Access Compliance Report

Public Rights-of-Way

(Curb Ramps)

Intersection ID: N/A	Main Street: PALUSTRIS_CT	Cross Street: N/A	Location: E
ADA ID: A73041C6263D	Ramp Type: Perp	Initial Pass/Fail: Fail	Overall Compliance: No
Codes/Mitigation Info/Possible Solution		Field Measurements/Component Compliance	
Severity Score: 21.25

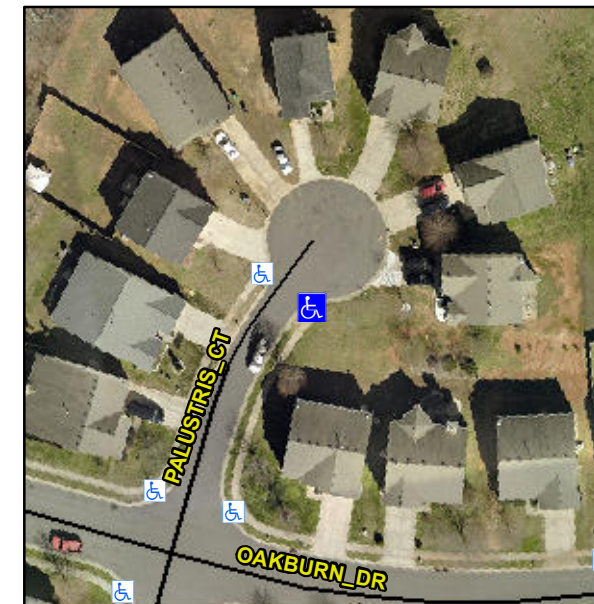
Not Found, R304.5.1, R304.2.2

Compliance	Description	Data	Compliance	Description	Data
N/A	Ramp Length (in)	48.0	No	Ramp Slope (%)	10.2
No	Ramp Width (in)	45.0	Yes	Ramp XSlope (%)	0.9
N/A	Flare Type LT	N/A	N/A	Flare Type RT	N/A
N/A	Flare Slope LT (%)	N/A	N/A	Flare Slope RT (%)	N/A
N/A	Flare Traversable LT?	N/A	N/A	Flare Traversable RT?	N/A
N/A	Landing Length (in)	N/A	N/A	DWS Provided?	N/A
N/A	Landing Width (in)	N/A	N/A	DWS Contrast?	N/A
N/A	Landing Slope (%)	N/A	N/A	DWS Length (in)	N/A
N/A	Landing X Slope (%)	N/A	N/A	DWS Full Width?	N/A
N/A	Landing Curb? (Y/N)	N/A	N/A	DWS Offset (in)	N/A
N/A	Shared Landing?	N/A			
N/A	Gutter Ponding?	N/A	N/A	Gutter Slope (%)	N/A
N/A	Gutter Lip Ht (in)	N/A	N/A	Gutter X Slope (%)	N/A
N/A	Painted X Walk1?	No	N/A	Painted X Walk2?	N/A
	X Walk 1 Direction	To W		X Walk 2 Direction	N/A
N/A	X Walk 1 Width (in)	N/A	N/A	X Walk 2 Width (in)	N/A
	X Walk 1 Slope (%)	1.6		X Walk 2 Slope (%)	N/A
	X Walk 1 X Slope (%)	4.0		X Walk 2 X Slope (%)	N/A

Remove & Replace Entire Ramp.
